BS-25

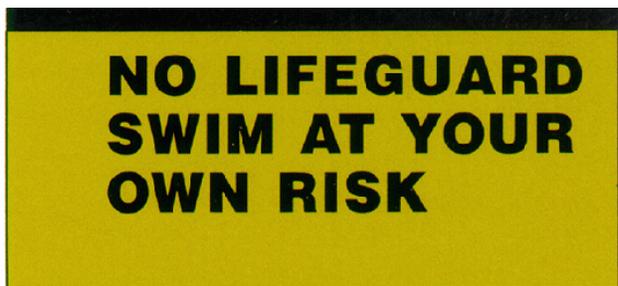
Danger Area Subject to Sudden Rising Water Flows

Good usage of black on red color scheme with Danger trigger word. Damage to sign reduces effectiveness and readability.

Replace sign, and assess maintenance schedule.

BS-26

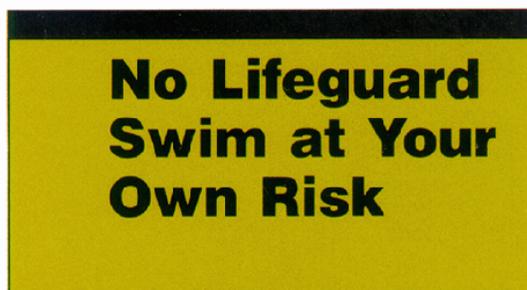
Incorrect: All capital letters

Correct: Initial capital letters

Comparison of all capital letters to only initial capitals. USACE uses initial caps to increase glance legibility and lower reading time.

Bottom sign capitalization meets USACE Standards. Both glance legibility and reading times may be important depending on the amount of time the viewer has to react to the warning. Consider these factors in sign design.
